Access Compliance Report

Public Rights-of-Way

Intersection ID: 15827	Main Street: CLANTON_RD	Cross Street: PELTON_ST	Location: NW
ADA ID: A172E6B6F49C	Ramp Type: PerpDiag	Initial Pass/Fail: Fail	Overall Compliance: No
		Severity Score: 12.5

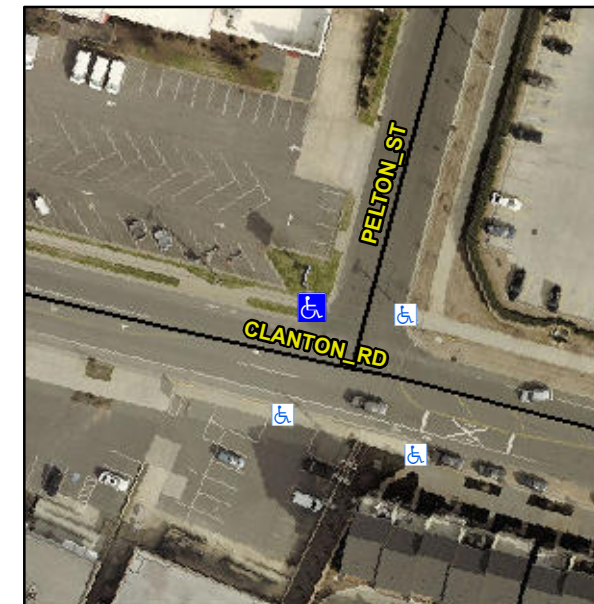
Not Found, R304.2.2

Remove & Replace Curb Ramp With Two New Directional Ramps or Equivalent.
